# Access Compliance Report

## Public Rights-of-Way

### (Curb Ramps)

Intersection ID: 53202	Main Street: FLINTROCK_RD	Cross Street: LITTLE_ROCK_RD	Location:	N
ADA ID: 351A8B5E19A2	Ramp Type: Perp	Initial Pass/Fail: Fail	Overall Compliance: No	Severity Score: 22.5

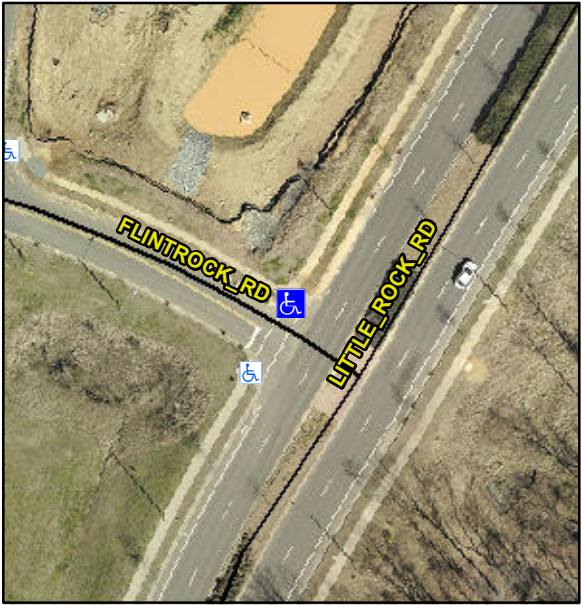
Codes/Mitigation Info/Possible Solution			Field Measurements/Component Compliance		
	Possible Solutions:		<b>Compliance</b>	<b>Description</b>	<b>Data</b>
	<b>Remove &amp; Replace Entire Ramp.</b>		<b>No</b>	Ramp Length (in)	<b>59.0</b>
			<b>No</b>	Ramp Width (in)	<b>46.5</b>
			<b>N/A</b>	Flare Type LT	<b>N/A</b>
			<b>N/A</b>	Flare Slope LT (%)	<b>N/A</b>
			<b>N/A</b>	Flare Traversable LT?	<b>N/A</b>
			<b>N/A</b>	Landing Length (in)	<b>N/A</b>
			<b>N/A</b>	Landing Width (in)	<b>N/A</b>
			<b>N/A</b>	Landing Slope (%)	<b>N/A</b>
			<b>N/A</b>	Landing X Slope (%)	<b>N/A</b>
<p>Surveyor Notes:</p> <p><b>N/A</b></p> <p>PROW/ADA:</p> <p><b>Not Found, R304.5.1, R304.2.2, R304.5.3</b></p>			<b>N/A</b>	Flare Type RT	<b>N/A</b>
			<b>N/A</b>	Flare Slope RT (%)	<b>N/A</b>
			<b>N/A</b>	Flare Traversable RT?	<b>N/A</b>
			<b>N/A</b>	DWS Provided?	<b>N/A</b>
			<b>N/A</b>	DWS Contrast?	<b>N/A</b>
			<b>N/A</b>	DWS Length (in)	<b>N/A</b>

<b>N/A</b>	DWS Full Width?	<b>N/A</b>
			<b>N/A</b>	DWS Offset (in)	<b>N/A</b>
			<b>N/A</b>	Shared Landing?	<b>N/A</b>
			<b>N/A</b>	Gutter Ponding?	<b>N/A</b>
<p>Total Cost:</p> <p><b>\$ 1850.00</b></p>			<b>N/A</b>	Gutter Lip Ht (in)	<b>N/A</b>
			<b>N/A</b>	Painted X Walk1?	<b>Yes</b>
				X Walk 1 Direction	<b>To SW</b>
			<b>N/A</b>	X Walk 1 Width (in)	<b>96.0</b>
				X Walk 1 Slope (%)	<b>3.4</b>
				X Walk 1 X Slope (%)	<b>4.8</b>
			<b>N/A</b>	Ramp inside XWalk1?	<b>Yes</b>
			<b>N/A</b>	Road Slope (%)	<b>N/A</b>
			<b>N/A</b>	Road X Slope (%)	<b>N/A</b>
			<b>N/A</b>	Any Obstructions?	<b>N/A</b>
			<b>N/A</b>	Obstruction Type	
			<b>N/A</b>	Clear Space?	<b>N/A</b>
			<b>N/A</b>	Clear Space to XWalk (in)	<b>N/A</b>
			<b>N/A</b>	Storm Grate/Utility Hazard?	<b>N/A</b>
				Storm Grate/Utility Type	
			<b>N/A</b>		<b>N/A</b>
			<b>Yes</b>	Surface Condition? (G/P)	<b>Good</b>
